<b>Subject:</b>  NEW MODEL SERVICE CAUTIONS	<b>Bulletin No:</b> 00-002/12
	<b>Last Issued:</b> 04/03/2012

- This bulletin supersedes the previous bulletin 00-002/12 issued on 03/16/12. The DESCRIPTION and SERVICE CAUTIONS have been revised.
- Changes are noted below in Red beside the change bar.

2013 CX-5

### Spark Plug:

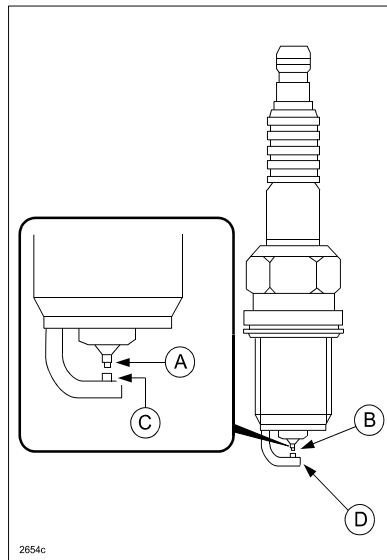
Only use the designated spark plugs for the SKYACTIV-G engine.

In order to achieve optimum ignition performance, SKYACTIV-G spark plugs use iridium (A) on an extremely thin center electrode (B) and platinum (C) on the ground electrode (D). Using general nickel or iridium plugs for the SKYACTIV-G engine could result in engine knocking, MIL illumination and/or poor driveability.

### **Tire Pressure Monitoring System (TPMS):**

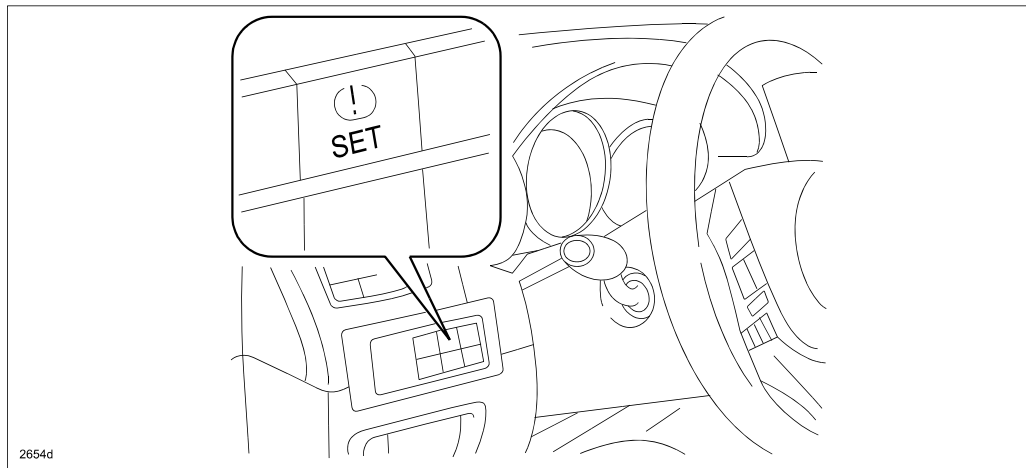
The tire pressure monitoring system monitors the tire pressure based on the signal from the ABS wheel-speed sensors on each wheel. With this system, initialization is required in the following cases:

- The tire pressure is adjusted (up or down) in one or more tires.
- A tire rotation is performed.
- Any tire or wheel is replaced.
- The vehicle's battery is disconnected, replaced or completely dead.
- **The DSC HU/CM has been replaced.**
- **The DSC HU/CM connector has been disconnected.**
- The TPMS warning light is illuminated.

### DTC U0151:00 Stored As Past Malfunction:

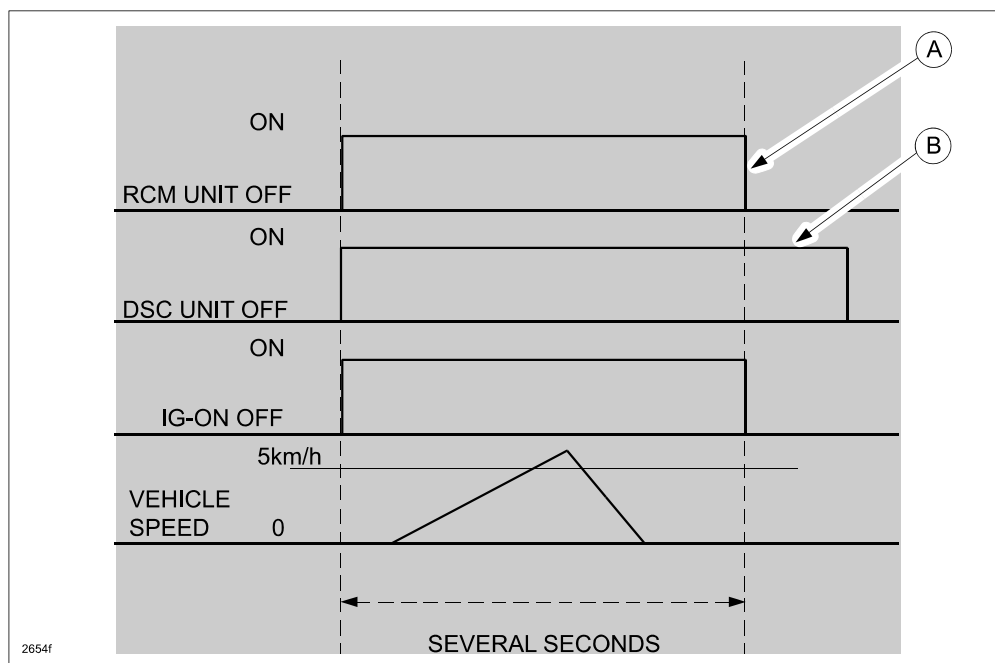
DTC U0151:00 ([DSC]: Communication error with SAS control module is detected in CAN communication) may be stored in memory as a past malfunction.

The DTC may be caused when the engine is started and the vehicle is driven immediately at 2 ~ 3 mph, then the ignition is turned off within several seconds.

While the DSC unit tries to communicate for a few seconds after the ignition is turned off, the RCM unit (SAS control unit) immediately stops communication when the ignition is turned off (A) at the self diagnosis stage. The DSC unit determines it as a communication error and sets the DTC as a result.

When the ignition is kept on longer than the self diagnosis stage (B), the RCM unit becomes able to communicate for a few seconds after the ignition is turned off, so the DTC will not be stored.

If DTC U0151:00 is found, check the following:

- Verify DTC U0151:00 is stored as a past malfunction.
- Other DTCs may also be stored that are not related to the symptom in this service information. Therefore, to eliminate DTC U0151:00, it is always recommended to check the service information independent from other DTCs.
- Check snapshot data item "IG-ON\_TIMER" (time since ignition switch ON). Verify the time is between "00:00" and "00:08" (mm:ss).

When all of the above factors are applicable, it is normal operation of the DSC and not a concern that requires a repair. Clear the DTC and check whether it occurs again under normal driving conditions. If the DTC recurs, refer to the online instructions on MS3 or the Workshop Manual for further troubleshooting information.
